Berrow Green, Martley

Ref: BGM-LE-GEN-XX-TN-CE-TN01

LLFA Response Statement

Lead Local Flood Authority Response in respect of M/23/01711/OUT - Outline planning permission for up to 55 dwellings (with means of access to the site be considered at this stage and all other matters reserved) at Land At (Os 7500 5952), Berrow Green Road, Martley

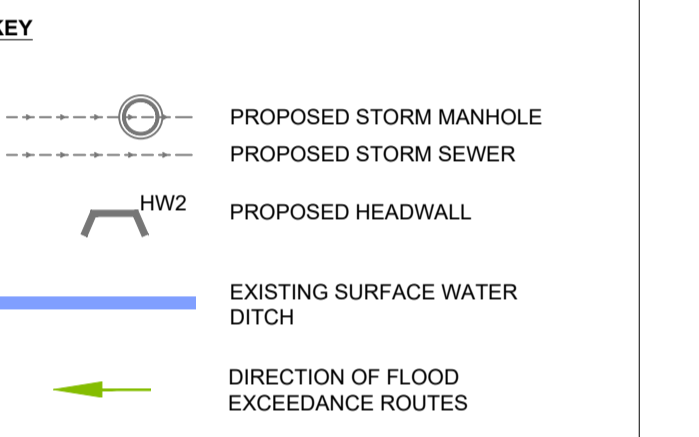
- 2.2 LLFA Comment: *“Calculations - The greenfield runoff rate (Qbar) has been calculated at 4.3l/s for the site and the proposed discharge rate is 4.75l/s up to the 1:100-year return period (1% AEP) + 40% climate change (CC) uplift. Why is the proposed discharge rate higher than Qbar, please justify this. The total attenuation storage proposed for the impermeable area is 1,486m³ up to the 1%AEP + 40% CC. There are no drainage calculations in the appendix to review.”*

Link Response: Please refer to the calculation extract Ref. BGM-LE-GEN-XX-CAL-CE-002 - Greenfield Runoff Rates Calculations in Appendix D of the FRA, which is repeated in **Appendix B** of this note. The Qbar for the total area within the redline boundary was found to be 7l/s however, not all of this area is to be developed. As outlined in Section 4.3.5 of the FRA, the flow rate restriction of 4.75l/s is based on the total impermeable catchment discharging into the watercourse, which is determined from the ratio of the impermeable area to the total site area within the redline boundary. Full drainage calculations were included in Appendix D of the accompanying FRA and are repeated in **Appendix B** of this note for reference.
